NL-05-0334

Vogtle Electric Generating Plant – Units 1 and 2
Response to Request for Additional Information on Request to Revise Technical
Specifications – Ultimate Heat Sink

Vogtle Electric Generating Plant – Units 1 and 2
Response to Request for Additional Information
Request to Revise Technical Specifications – Ultimate Heat Sink

Figure 1 - Marley Cooling Tower Performance Curves

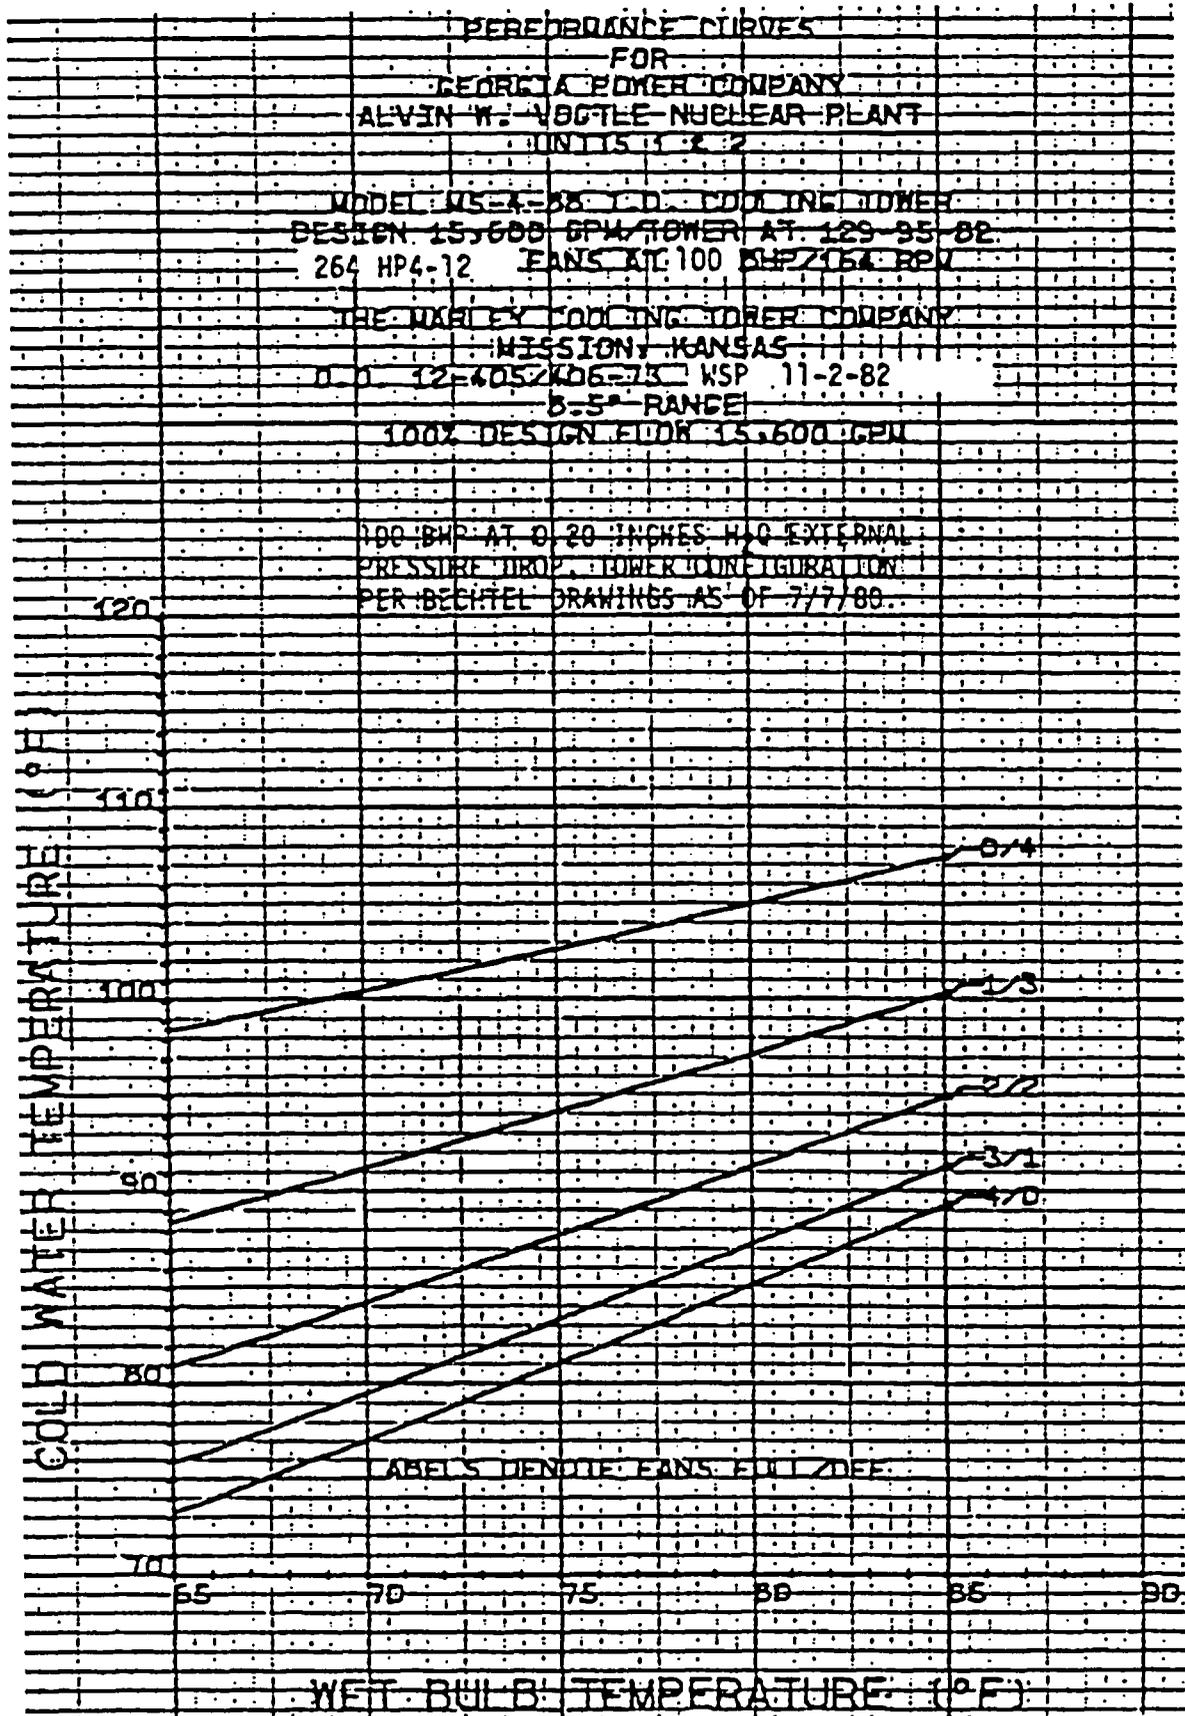
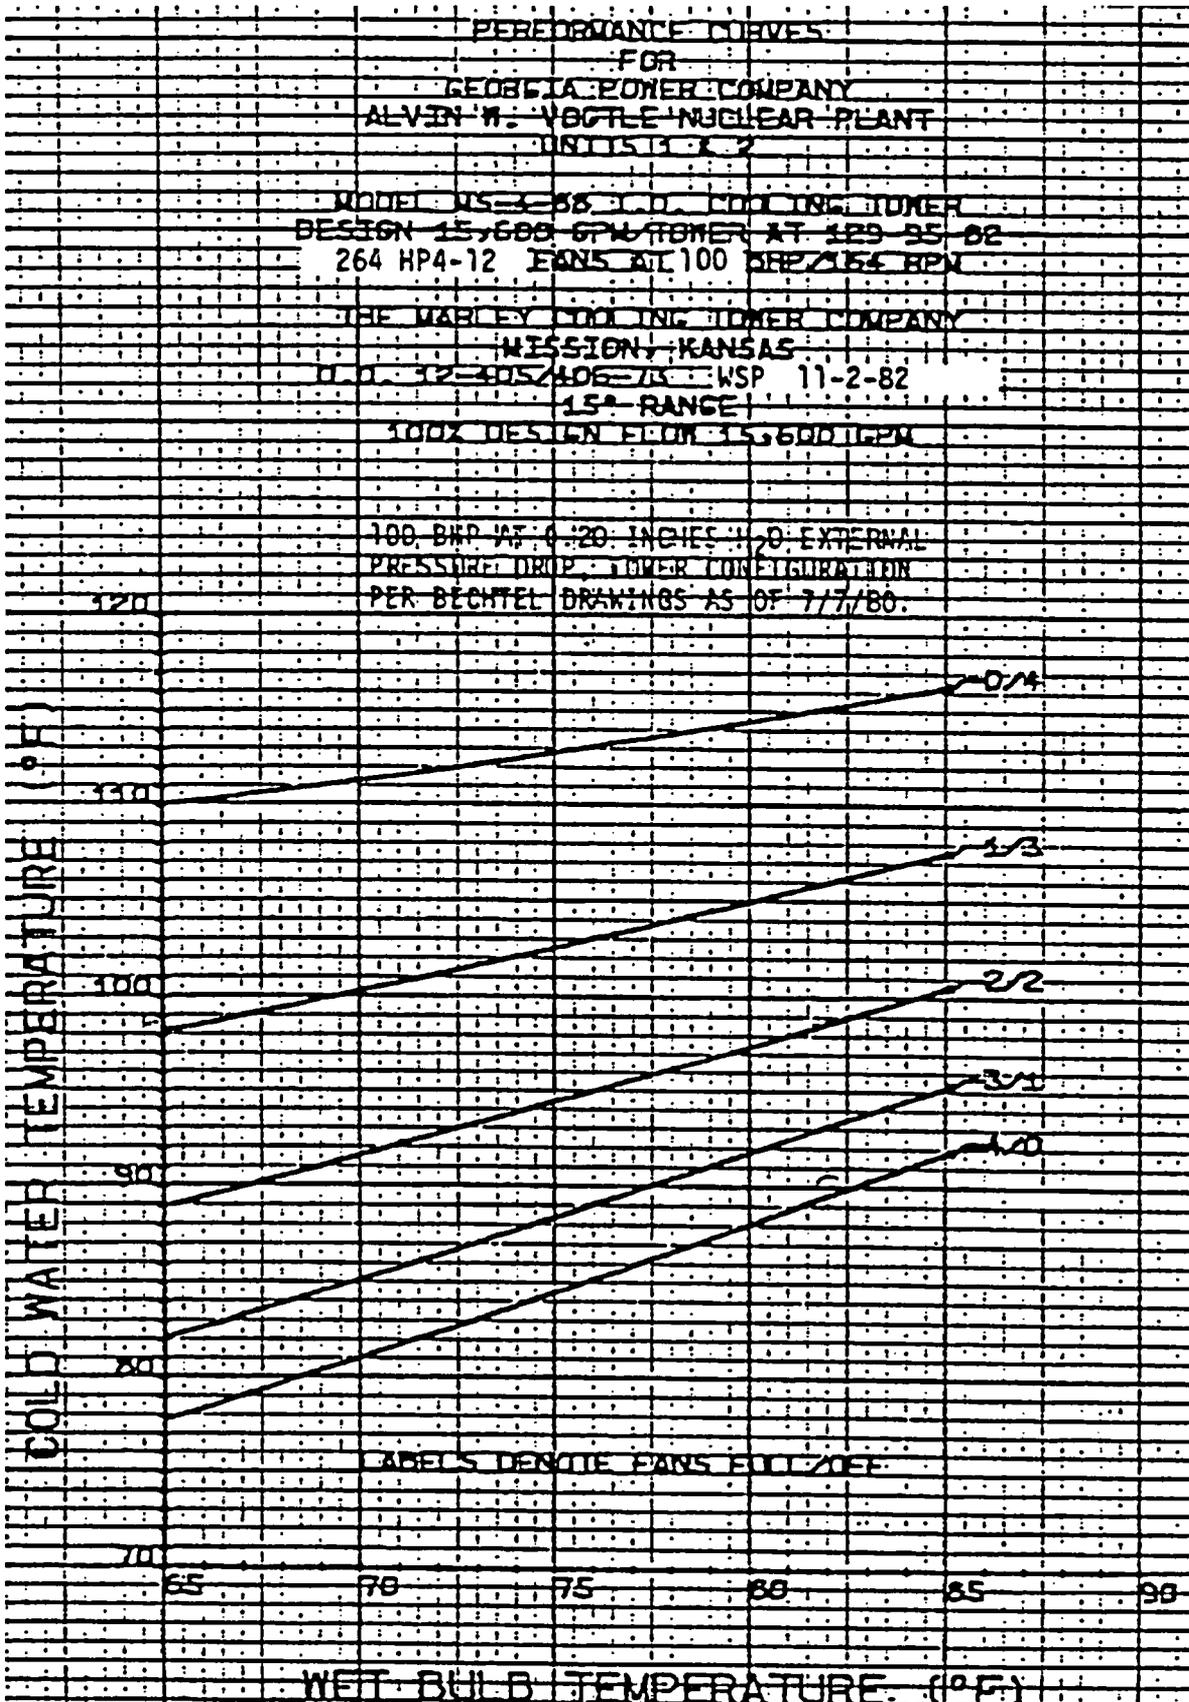
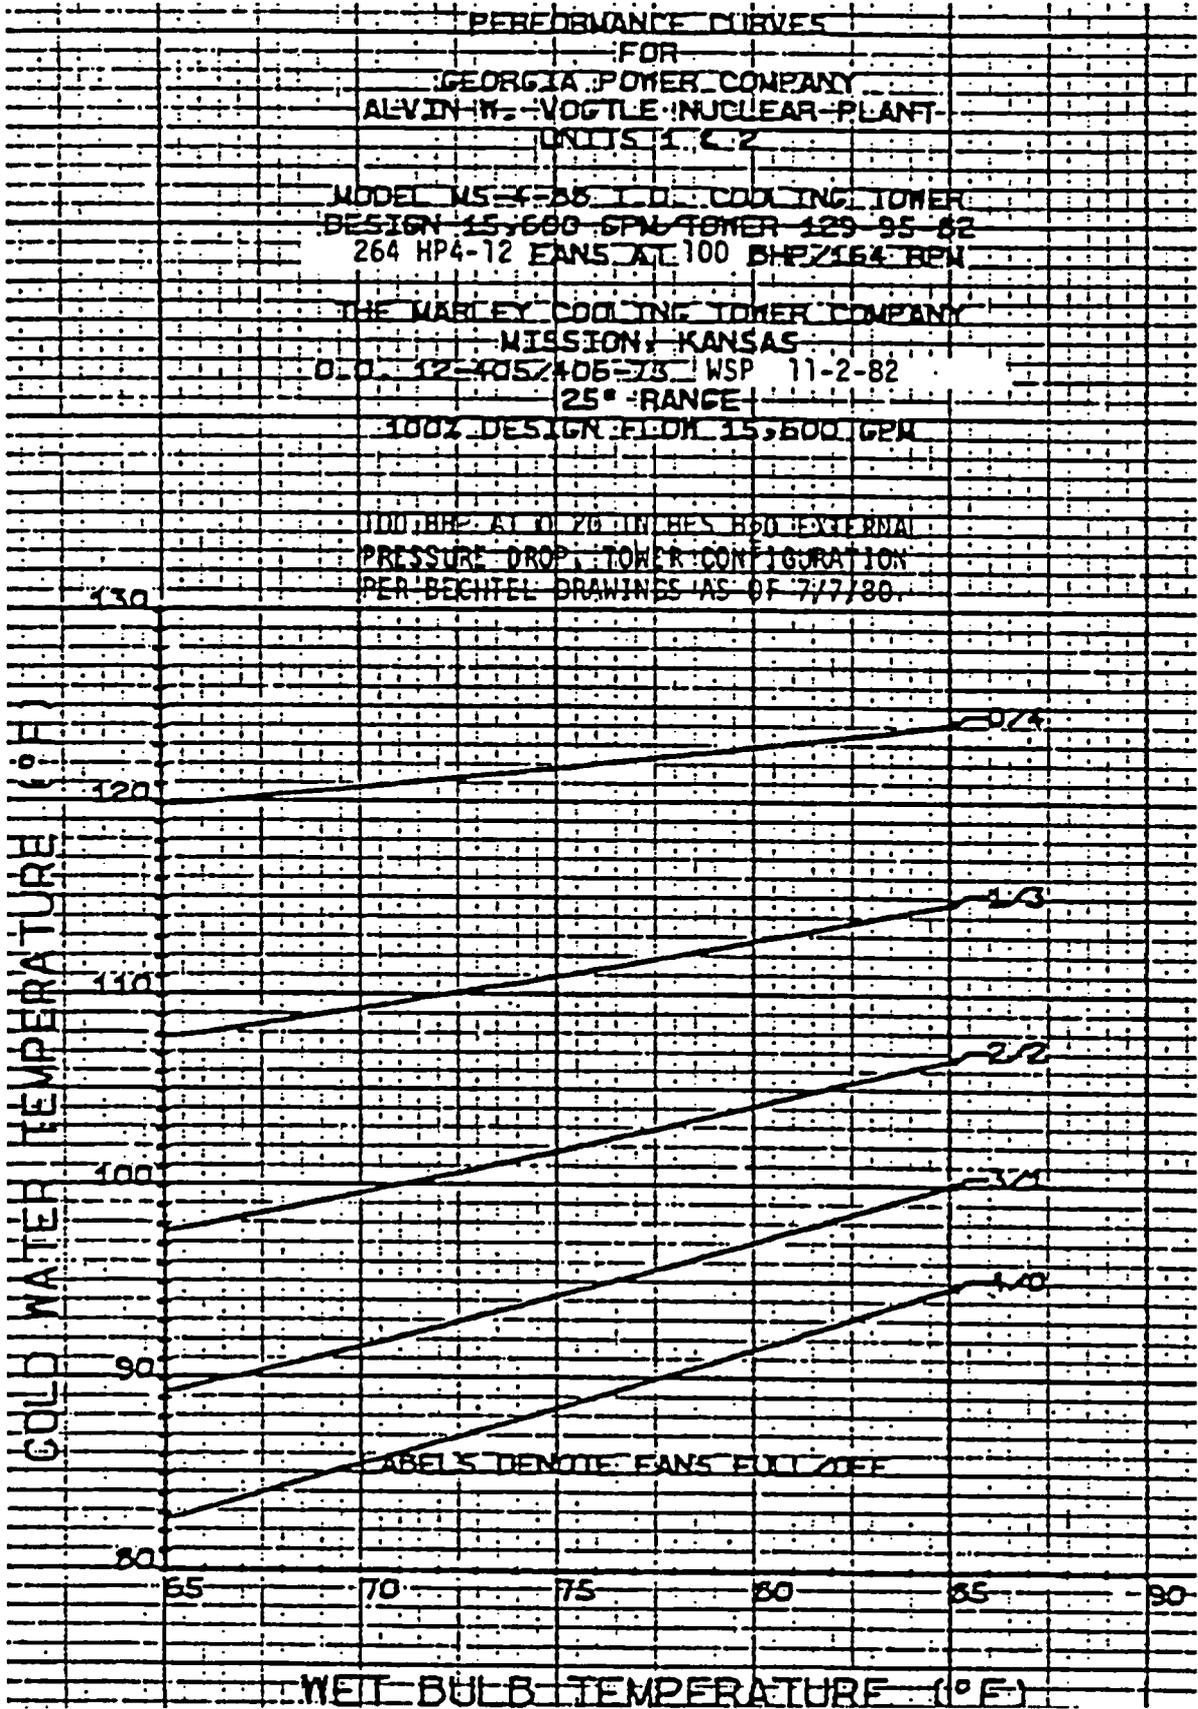
The SNC's LAR does not provide sufficient technical basis for supporting operation of the nuclear service cooling water (NSCW) system with (1) one fan out-of-service or (2) one fan out-of-service and one fan lost with loss of offsite power due to tornado. Using Marley cooling tower performance curves, the SNC determined that the ambient wet-bulb temperatures that are necessary to support cooling for normal operation, shutdown, and emergency operations at the above conditions were 67 and 63 °F, respectively. These temperature values, as stated in Enclosure 1 to the LAR, in part consist of the basis for the licensee's proposed changes. Please provide the cooling tower performance curves and assumptions used in determining the above values for staff review.

The Marley tower performance curves (see Figure 1 attached to this Enclosure) provide the cooling capacity of the NSCW towers with one, two, three, or four fans in operation. The required tower conditions are full water distribution and fan stacks not blocked (so that the non-operating fan stacks allow additional cooling due to natural draft).

The NSCW cooling towers were designed to operate during normal plant operation, cooldown, and emergency operations assuming a wet-bulb temperature of 82°F. Emergency operations provide the highest tower heat loads (described below) and bound the other conditions.

Each tower is designed to reject 265 million BTU/ hr, which at a flow rate of 15,600 gpm provides a design range of 34 degrees. There are four operational conditions which are described as follows.

- A) Three conditions rely on four operating fans including plant cool-down with a loss of off-site power (LOSP), a main steam line break, and a loss-of-coolant-accident (LOCA).
- B) One condition relies on three fans operating in which a single train of NSCW operates four hours after station blackout with the fourth fan lost from service due to a tornado missile.

The Marley tower performance curves were used to determine the reduced wet bulb temperatures at which the heat loads (34 degree range) could be met with an additional fan removed from service for maintenance.

Three fans satisfy cooling loads at a wet-bulb of 67°F for the conditions described above in (A). Two fans satisfy the cooling load at a wet-bulb of 63°F for the conditions described above in (B). A temperature of 63°F wet-bulb is bounding for taking a fan out of service under all conditions.
